Meander Valley Council

ORDINARY AGENDA

Tuesday 8 August 2017

The proposal is to construct two units at 6 Carlwood Place in Prospect Vale. Unit 1 is a single storey three bedroom unit. Unit 2 is a single storey two bedroom unit. Each unit has a double garage and separate access to Carlwood Place. A 1.8m high fence on a 400mm high retaining wall separates the two units.

Figure 1: Plan of subdivision (D. J. McCULLOCH Surveying, 2017)

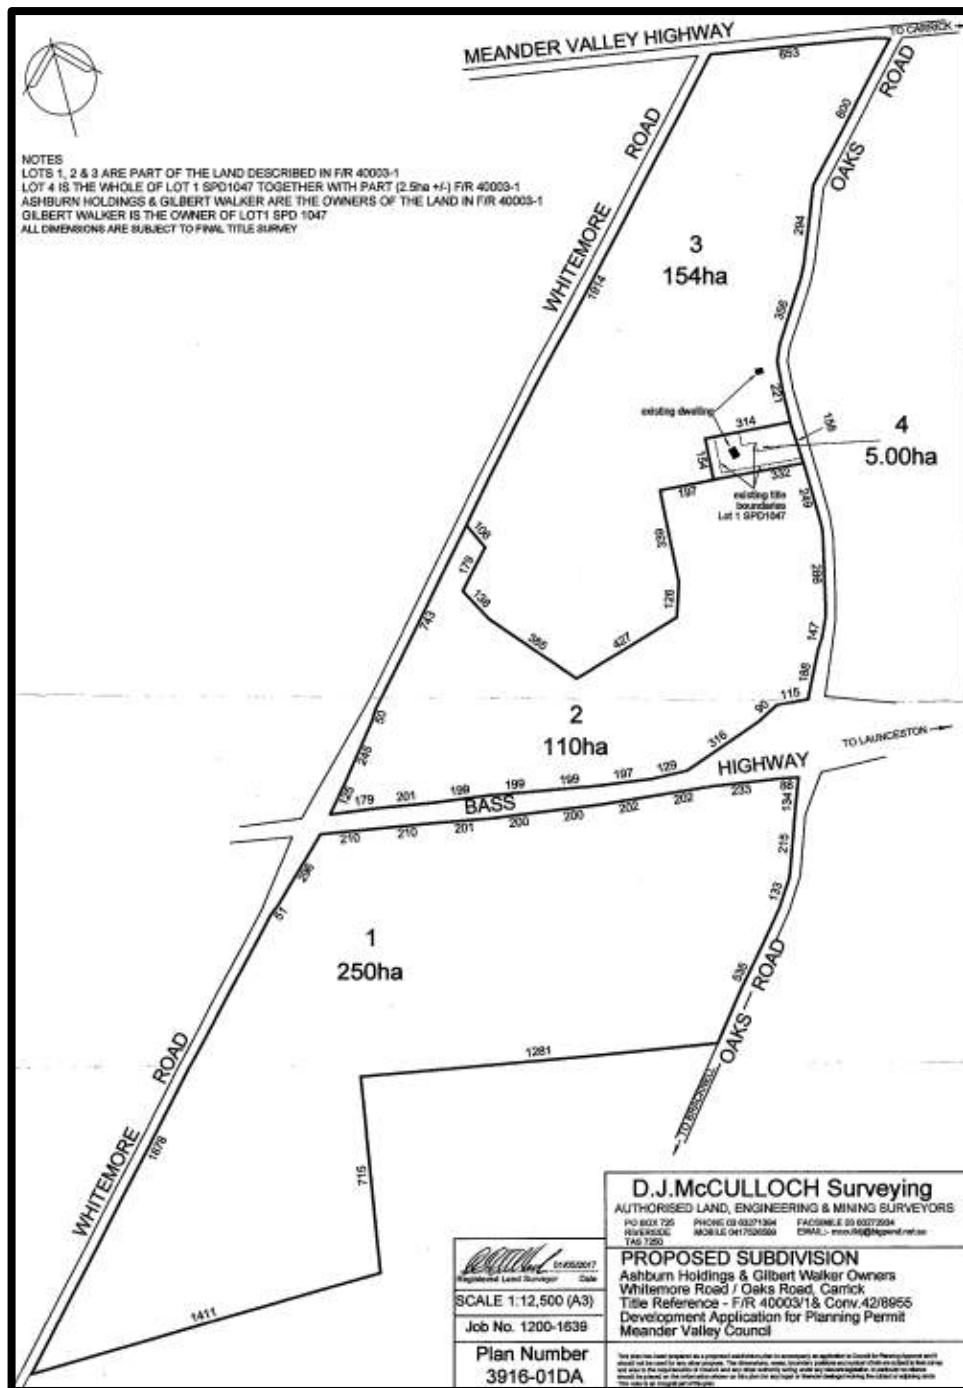
In order to comply with Clause 9.3 Adjustment of a Boundary there must only be a minor change in the relative, size, shape and orientation of the lots. The proposal will result in the area of CT:42/8955 effectively doubling from 2.5ha to 5ha. The land will be converted to a residential use. This boundary adjustment is not considered to be a minor change due to the title increasing in area by 100%.
